**NEI 00-04 (DRAFT - Revision B)**

# **Option 2 Implementation Guideline**

**May 2001**

Figure 2.4-1

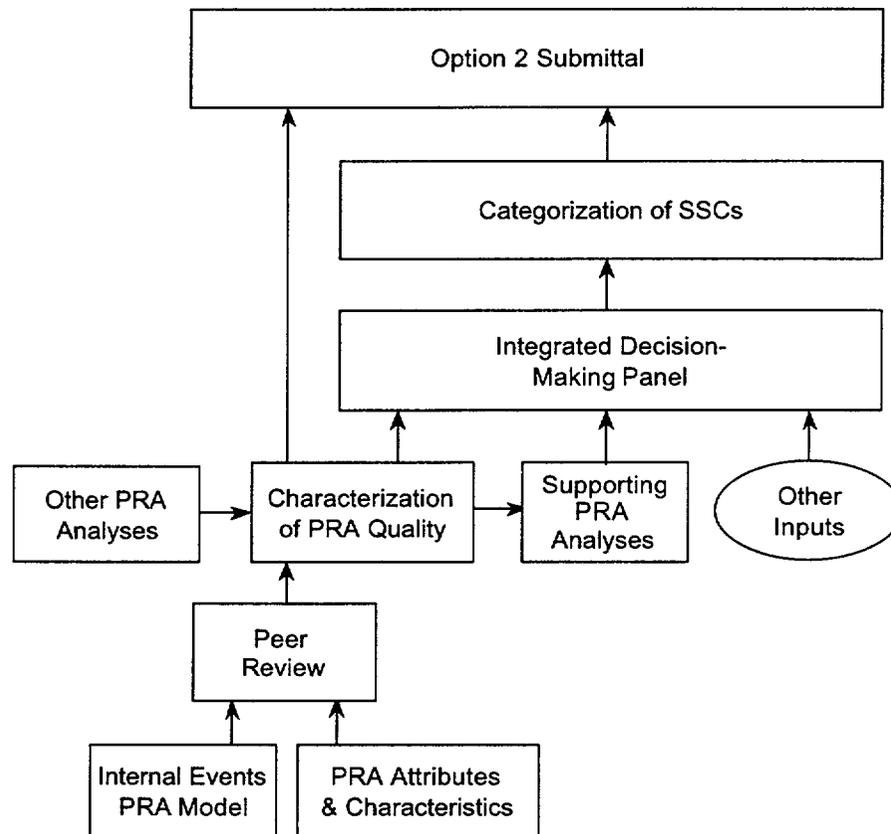
7. If the title of Figure 2.4-1 is to remain as "Overall Safety Significance Process," the endpoints of all paths should lead to the IDP for consideration of defense-in-depth, safety margins, etc. Otherwise, the figure would be more appropriately titled "Use of Risk Analyses for SSC Categorization" or similar. Also, from this figure, there are six different reasons why an SSC can be deferred to the IDP for deliberation. Is there a mechanism to relay to the IDP the reason(s) why they are deliberating on an SSC, i.e., how does the IDP know specifically what it has to focus on?	The title of the figure has been changed as suggested.  Section 2.4.2.7 describes the information to be provided to the IDP. This includes a description of the PRA classification and other considerations, including defense-in-depth.

Figure 2.4-2  
USE OF RISK ANALYSES FOR SSC CATEGORIZATION

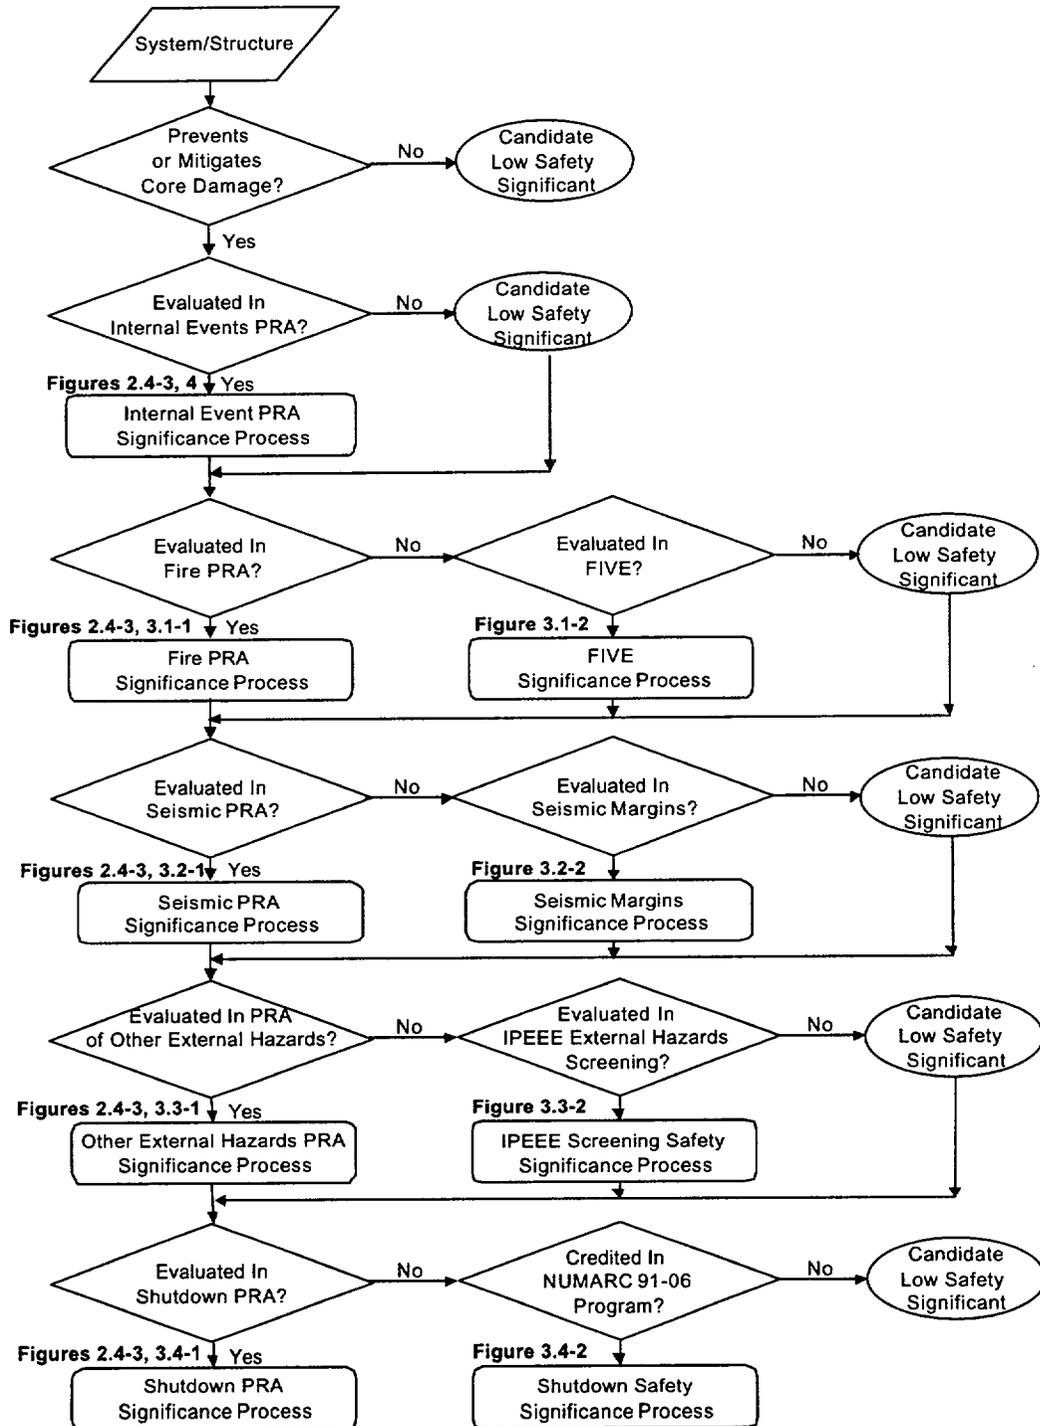
NRC COMMENT	DISPOSITION
<p>9. In the third from the last paragraph on page 25 and in Figure 2.4-2, the evaluation of components within the system is based on whether the component is "required" to support a safety function evaluated in the PRA. The term "required" could be misinterpreted such that a component would not be considered to be "required" if there were a redundant component that could perform the same function. The document should use the term "credited" instead of "required" to avoid this problem.</p>	<p>The term decision block "Required to Support PRA Function?" has been replaced with "Implicitly or Explicitly Modeled in PRA?" The text has been modified to match the figure.</p>
<p>10. In several places in the document (e.g., the first paragraph on page 26, the second full paragraph on page 27, and Figure 2.4-3), reference is made to "candidate safety significant SSCs" for which safety significant attributes are to be identified. This implies that the SSCs themselves are not safety significant but that certain functions that they perform are safety significant. It is not clear how this relates back to the failure modes modeled in the PRA. For example, in the table on page 27 titled "Example Importance Summary", none of the failure modes would exceed the F-V guideline by itself, so how would the safety significant attribute of this component be identified? Also, how are passive functions, e.g., preserving pressure boundary, taken into account?</p>	<p>All failure modes in the PRA are used to identify whether the SSC meets the importance measure screening criteria. This is a conservatism in the screening process. In identifying safety significant attributes, only the failure mode(s), which cause the screening criteria to be met, are used.</p> <p>Section 2.4.2 has been modified to reflect this.</p>
